PREVOST

WARRANTY BULLETIN

WB23-29

DATE :	January 2024	SECTION :	06 ELECTRICAL
EXPIRATION:	January 2026		
SUBJECT:	CABLES AND SOFTWARE MODIFICATION FOR THE UNLATCH CONTROL

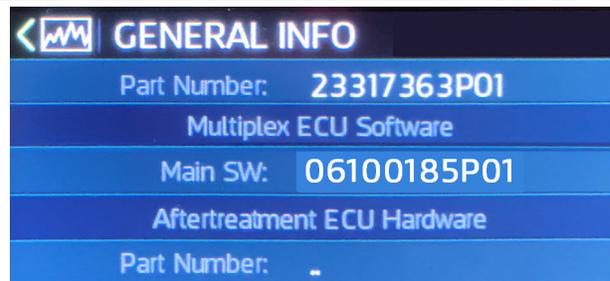
4. Scroll to **Multiplex ECU software**. The DID show the multiplex software number and the actual revision number just after the letter "P".

5. Take note of the vehicle multiplex software **06100185PXX** change for **062100192PXX**.
6. Compare the vehicle multiplex software if you have software **06100185PXX** you must perform safety recall **SR23-07** before to do modifications that follow.

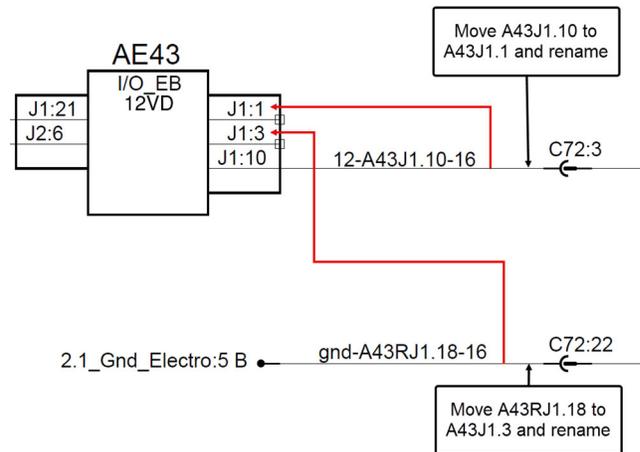
5. Locate wire **A43J1.10** use the terminal extractor 687976 to remove it from the connector.
6. Change the wire identification to **A43J1.1**.
7. Insert the terminal at **A43J1.1** in connector.
8. Locate wire **A43RJ1.18** use the terminal extractor 687976 to remove it from the connector.
9. Change the wire identification to **A43J1.3**.
10. Insert the terminal at **A43J1.3** in connector.

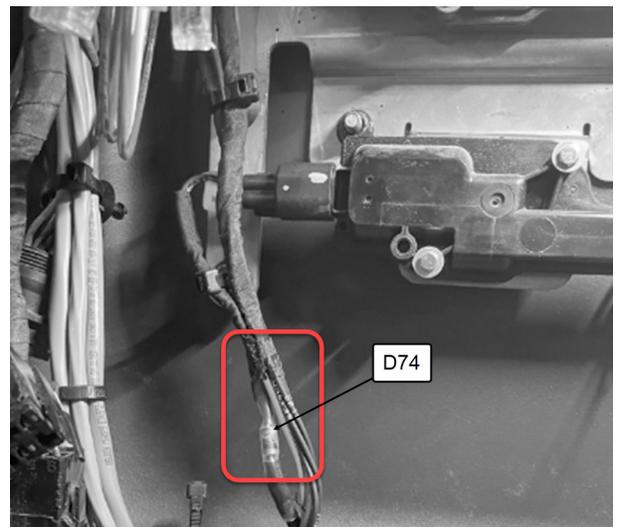
5. Remove tape and locate the diode **D74** on the cable.

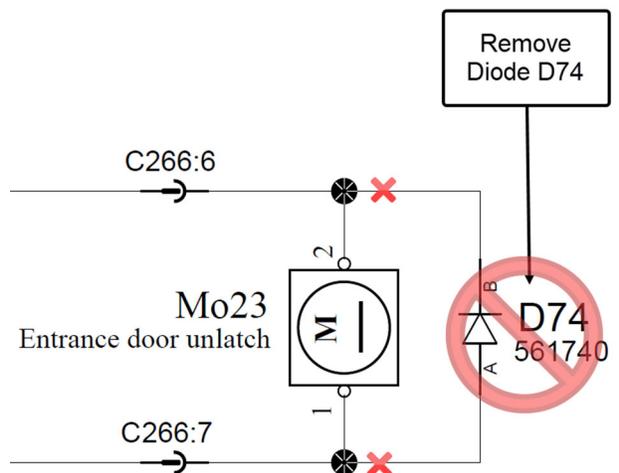
6. Remove the diode **D74** cut at the splice.
7. Apply shrink tubing to the two wire ends that are cut when the diode is removed.
